Urban Design Memo

Subject: Urban Design Comment – Rotokauri North Private Plan Change

Date: 5 July 2021 File: _____

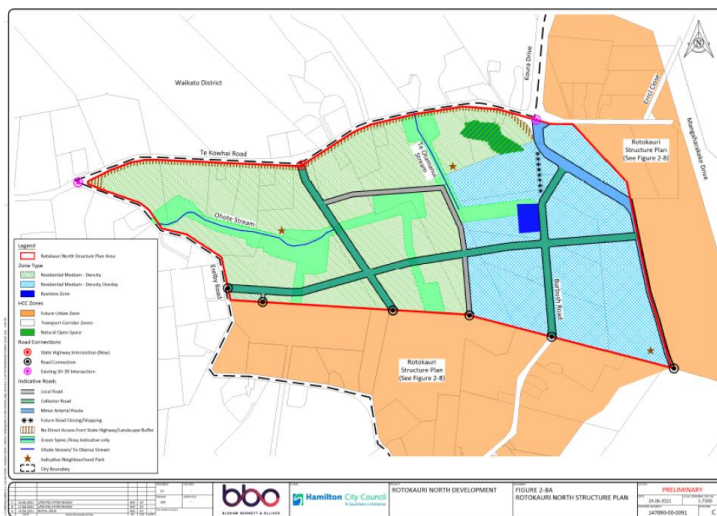
9. Work on this portion of the growth cell has been ongoing for a few years. The goal is to ensure that any development proposal reflects the application of best-practice urban design principles.
10. To this end, several design workshops were held which led to the development of an indicative Masterplan (see image below) showing a preferred option (one of several alternatives explored) for how the land could be subdivided to support a high-quality residential neighbourhood.

11. Although the Masterplan will remain as a non-statutory document, the outcomes achieved demonstrate the value of the process. The Masterplan underpins and provides the basis for all the provisions and maps that have subsequently been drafted, giving HCC and others confidence that the stated urban design outcomes can be achieved.
12. Based on the above master planning process and refinement, I believe that the proposed Structure Plan (see below) builds on the various opportunities and constraints that the site presents and that it presents a well-considered alternative for this portion of the wider Rotokauri growth cell.

13. The masterplan was not submitted to the Urban Design Advisory Panel.
